Heathrow Airspace Modernisation - Stakeholder Engagement

Community Presentation to the NACF meeting 20 March 2024

Submission to CAA by TAG 5 September 2023

Airspace Modernisation: Airspace Change Proposal
Stage 2 Submission - Step 2B Engagement on Initial Options Appraisal (IOA)

Airbus A320 – 60 dB LAmax contour vs Overflight Metric

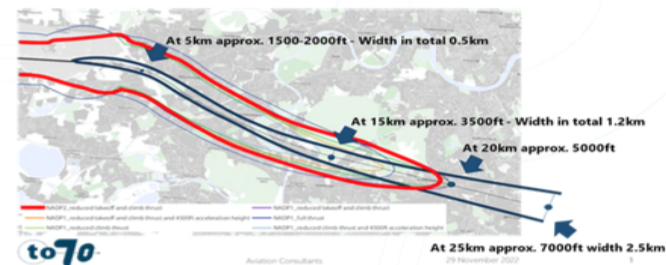
Impact of Flightpaths - use of overflight contours to suggest noise impacted areas is especially misleading near the airport and where paths diverge. The overflight metric may suggest some separation of noise from different flight paths whereas in reality there will be continuous noise. A simple 3km wide path (1.5km each side from the centreline) would give a better indication of noise impact. Overflight metrics seem to be the main way Heathrow has chosen to display options; however, this is fundamentally misleading and suggests much less noise near the airport which is not the case. The following graphic has already been shared and shows a A320 60dB Lamax noise contour in Red being much wider than the dark blue overflight metric;

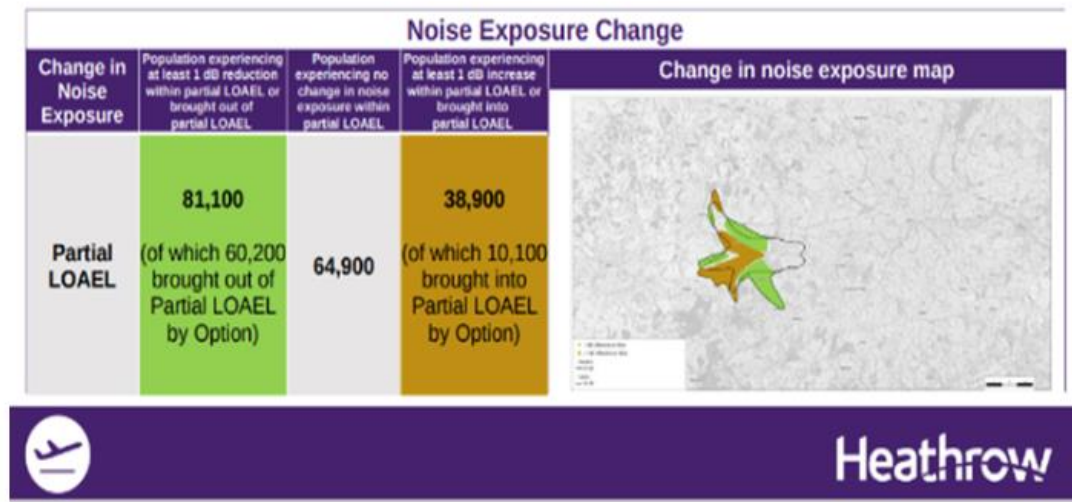
Change and Concentration – it is clear from Heathrow's 2014 trials and US experience these issues remain key considerations and need to be fully understood (the DfT admitted at the NACF that no UK study of health impacts associated with highly concentrated PBN flight paths has been undertaken). Andersen Acoustics analysis of the 2014 PBN trials showed the

trials generated multiple complaints far beyond the UK LOAEL levels. Complaints received today by Heathrow go beyond the UK LOAEL levels. The fact that levels of annoyance are being created to cause people to complain cannot be ignored especially as the UK SoNA 2014 never covered any areas below 51dB LAeq. WHO (2018) shows significant annoyance to 45dB Lden levels. Change should be measured to at least 45dB LAeq and preferably to 42dB LAeq (the WHO 45 dB Lden equivalent). Although the diagram below (from the supplied documents) shows change, as it only looks at a single >+/-1 dB LAeq change level, it is not clear if there are any areas of >2dB >3dB and larger change which would show further concentration impacts. This diagram should be extended with further change level contours used (2dB,3dB etc) in the assessment up to and including the highest level of change seen.
